PLANNING, ZONING, & BUILDING DEPARTMENT PZ&B Staff Memorandum: Architectural Commission

ZON-24-017 (ARC-24-007) 222 WORTH AVE (COMBO) SUBJECT:

MEETING: MARCH 27, 2024 ARCOM

January ARCOM Proposal

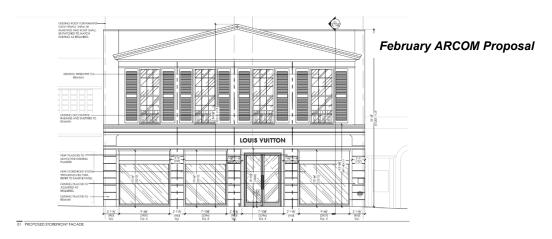
At the January the two existing glass and frame systems with new glass and frame systems with a black metal finish. A new entry door, a single door with sidelight with black metal and glass was proposed to be installed to replace the existing double door. New black awnings were also proposed, while the existing exterior lighting was programmed to remain. The most architecturally significant portion of the application was the alteration of the ground floor façade—specifically the removal of the arched window and door along the easternmost portion of the elevation to infill with a new glass and frame system to match the geometry of the existing stucco façade including pilasters in the façade with a smaller glass storefront system:

March ARCOM Proposal

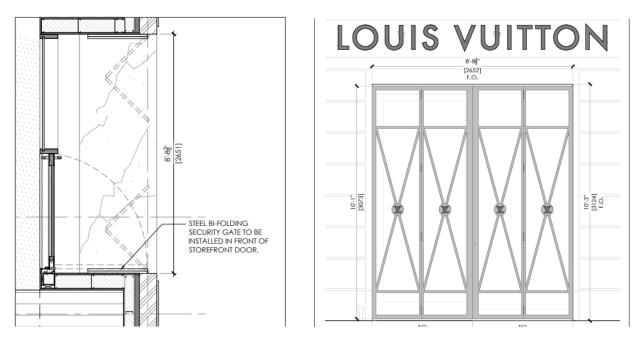
The latest revision modifies the location of the pilasters to create a storefront that is organized into four bays with a brass finish. The entry door has been recessed from the façade and is proposed with a single (equally sized) sidelight. An ornamental security has been proposed that references the divided-light pattern of the transoms and contains Louis Vuitton logos. The three remaining bays feature transoms and knee walls, as depicted in the original façade drawings. The signage is located above the entry door. The existing finials will remain. As previously proposed, the arched window and door along the easternmost portion of the elevation were removed:

Finally, the security grill has been redesigned to be a bifold security gate in front of the new entry. Said steel gate will continue the transom line and allow for transparency into the store and provide for security in an aesthetically more pleasing manner than a traditional roll down security metal mesh screen gate.

Staff does have some questions about the color, material, opaqueness, and details of the bi-folding date, including size and materiality of the proposed logo buttons. Should the Commission find merit in the proposal, such design details could be handled administratively as a review with specific direction by the Commission.
